SACRED HEART SCHOOLS MASTER PLAN EIR

STATE CLEARINGHOUSE #2009112052

SACRED HEART SCHOOLS MASTER PLAN PROJECT
FINAL ENVIRONMENTAL IMPACT REPORT

I. INTRODUCTION

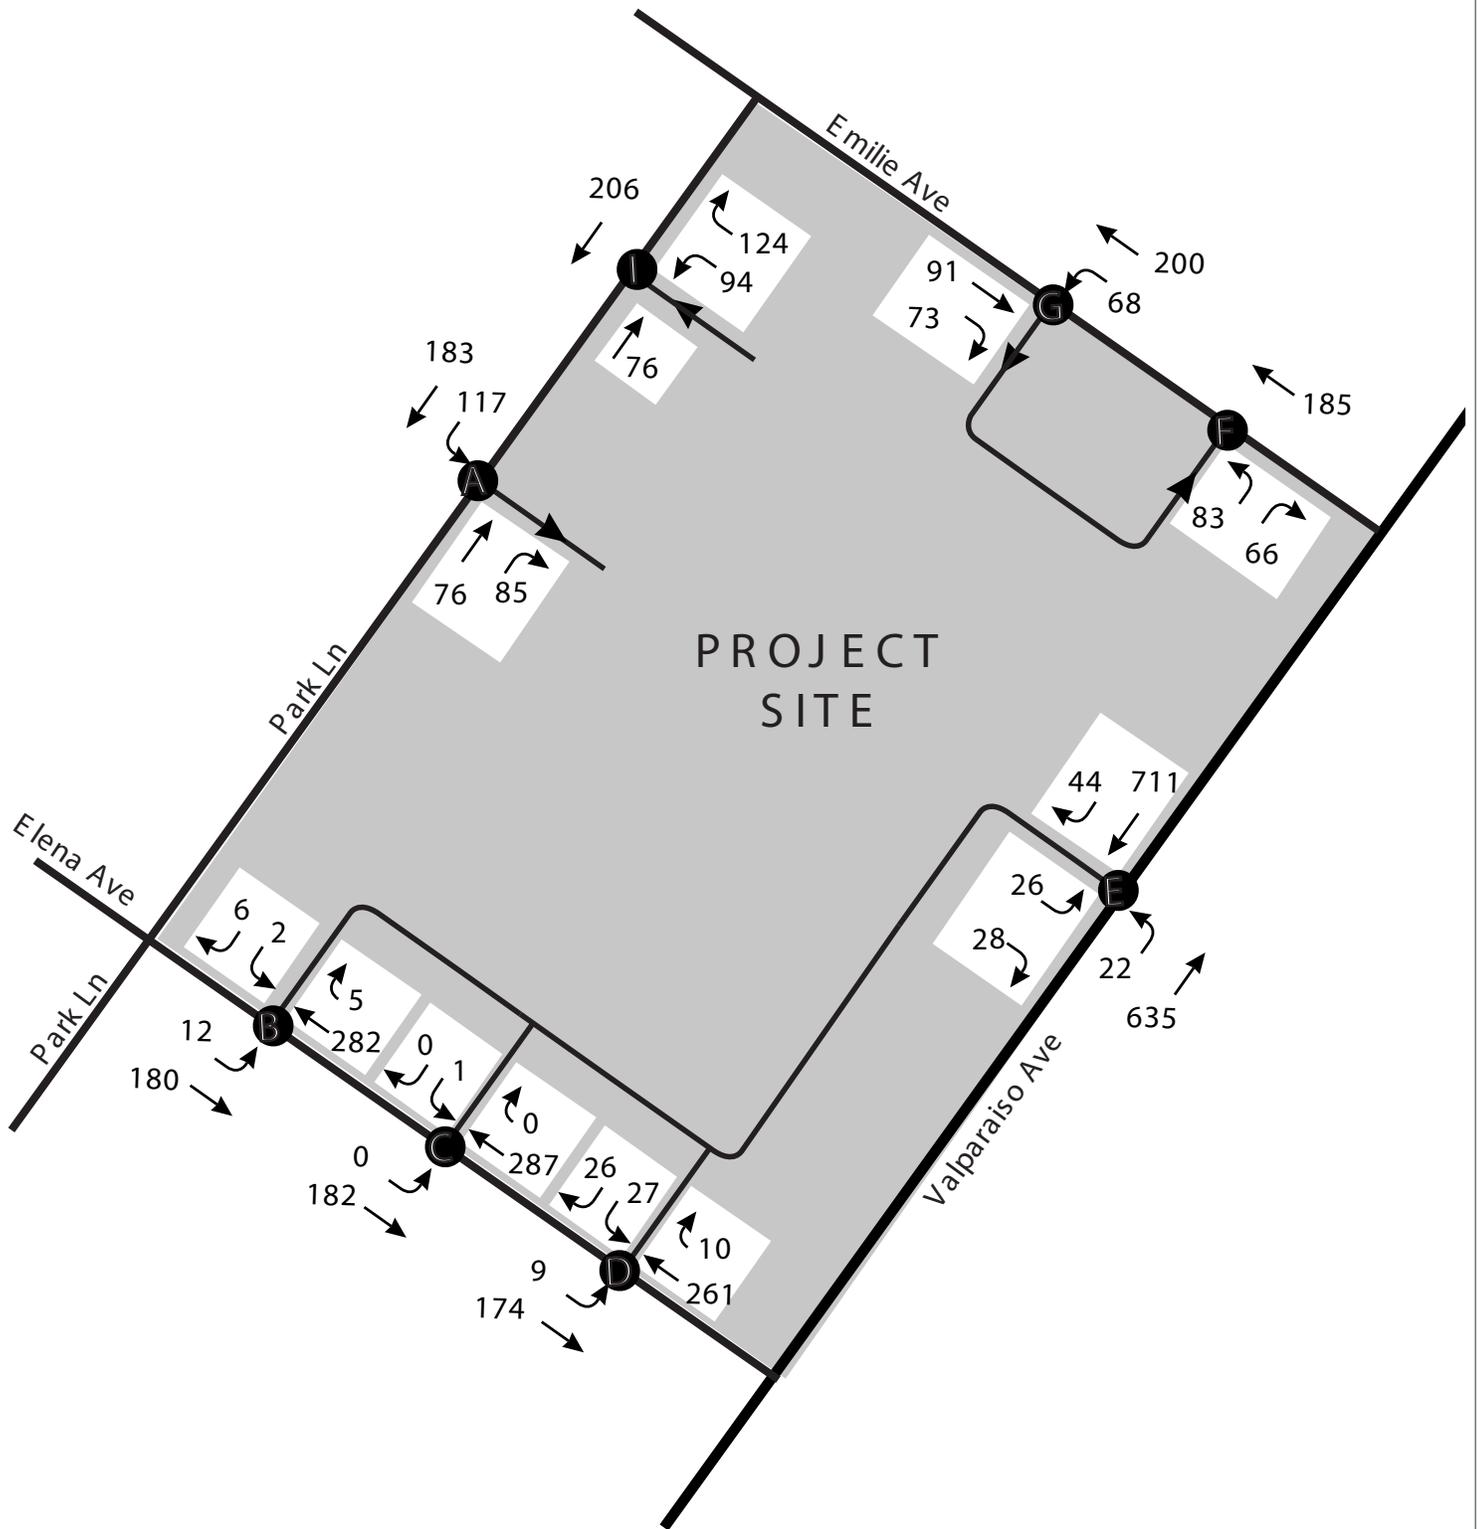
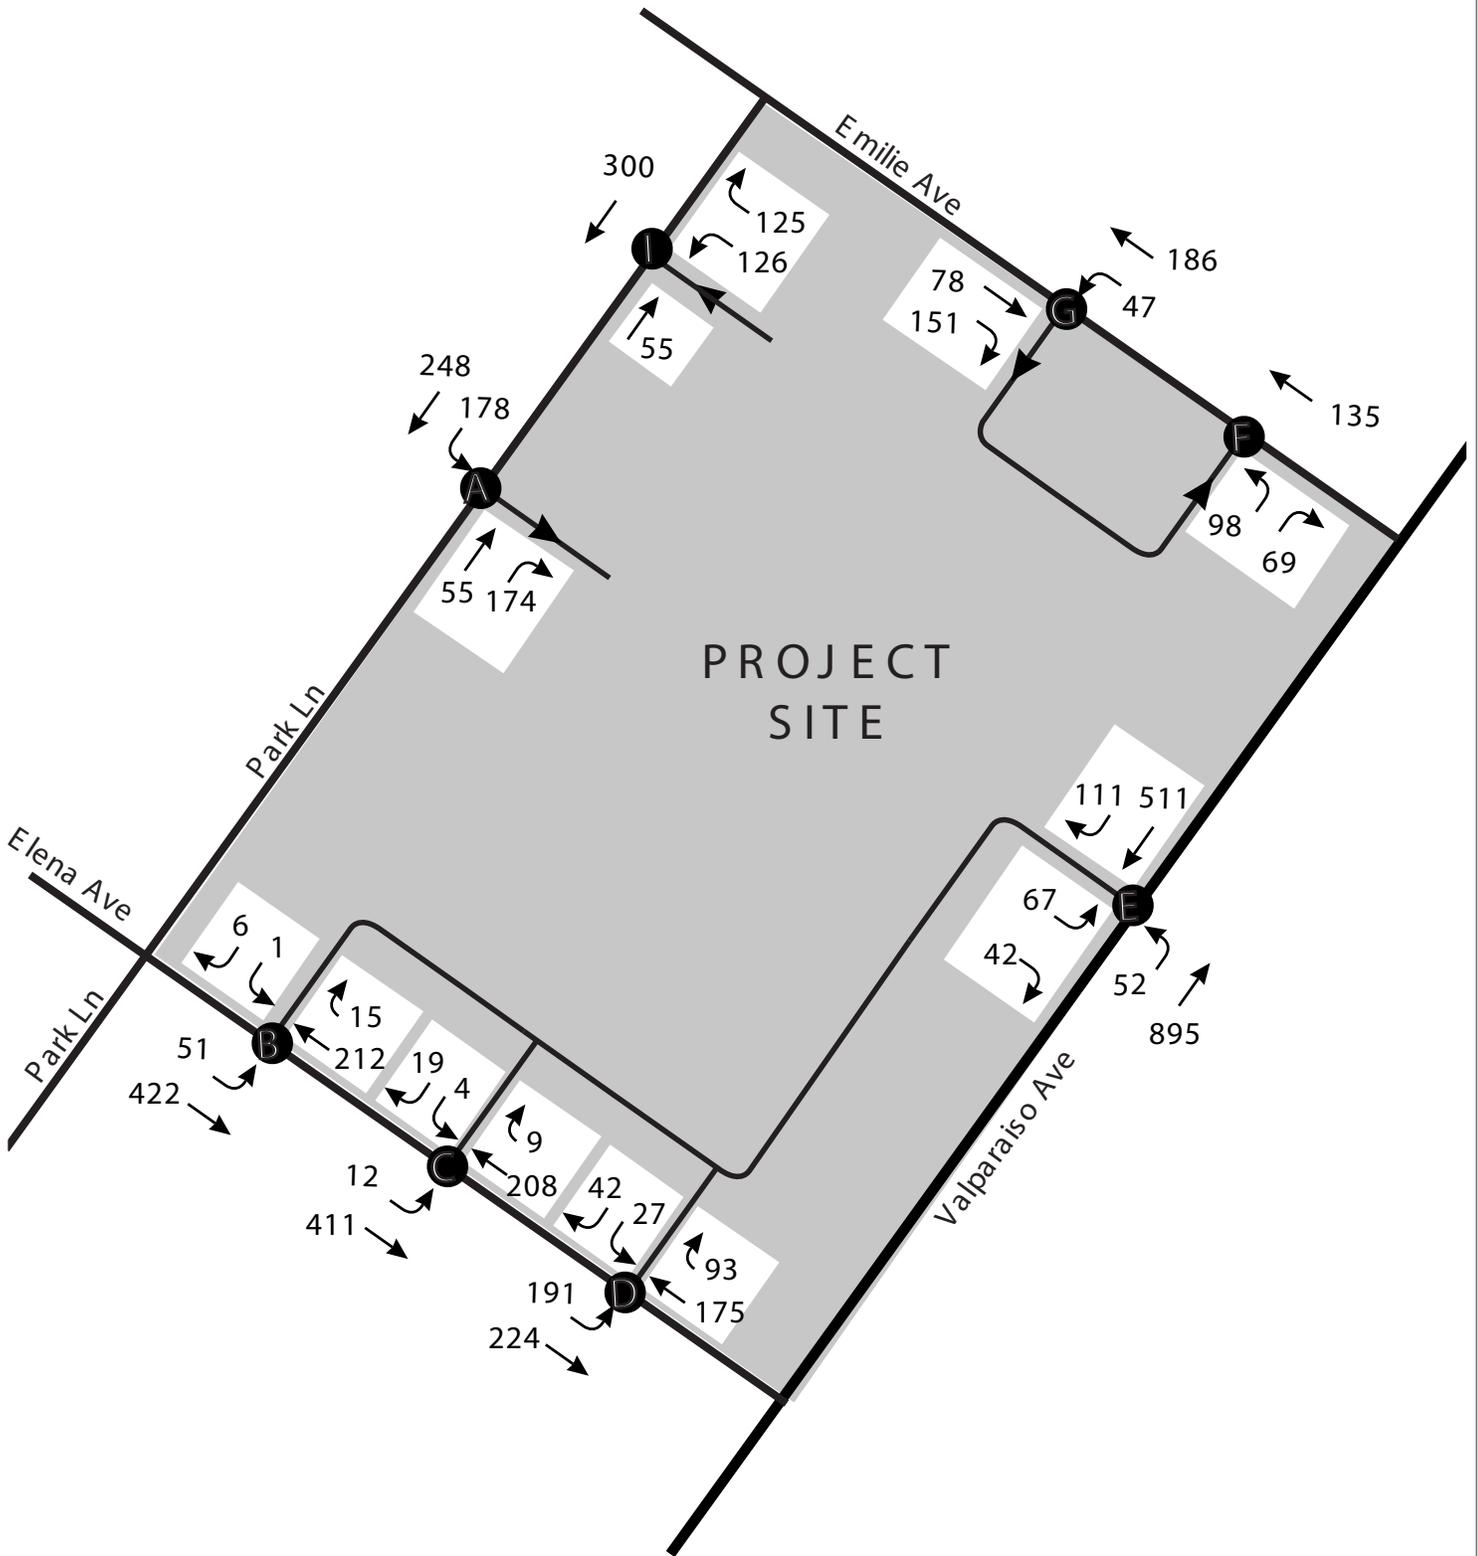
Figure IV.G-15, Please note that Figure IV.G-15 should be revised to clarify that the entrance from Park Lane is ONE WAY inward. The exit “I” is ONE WAY outbound. There should not be any exiting traffic counted at “A” in these figures.

Figure IV.G-15. It is noted that the entrance from Park Lane is a one-way inbound driveway. All outbound traffic shown at this driveway would be added to the outbound only driveway. This would not produce any change in findings. Figure IV.G-15 has been revised.
